JIFFY STAND SUPPORT PLATE / 1974 FX, FXE

HARLEY-DAVIDSON MOTOR CO., INC.

Jiffy stand support plate
Part No. 50036-74

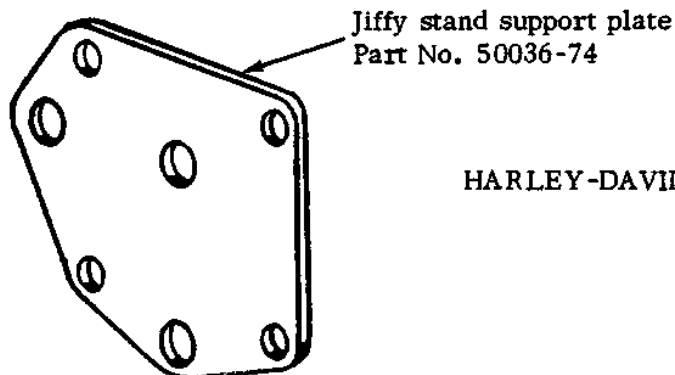
A support plate has been added to late 1974 FX/FXE-1200 models (starting with VIN 2C or 9D 38536 H4) to eliminate possible bending at the Jiffy Stand mount. The plate, part No. 50036-74, is assembled between the Jiffy Stand and the rectifier-regulator mounting bracket.

This plate should be installed under warranty, on early 1974 vehicles. Dealer's account will be credited the dealer net price of \$.33 for each part upon receipt of a properly completed warranty form at the factory.
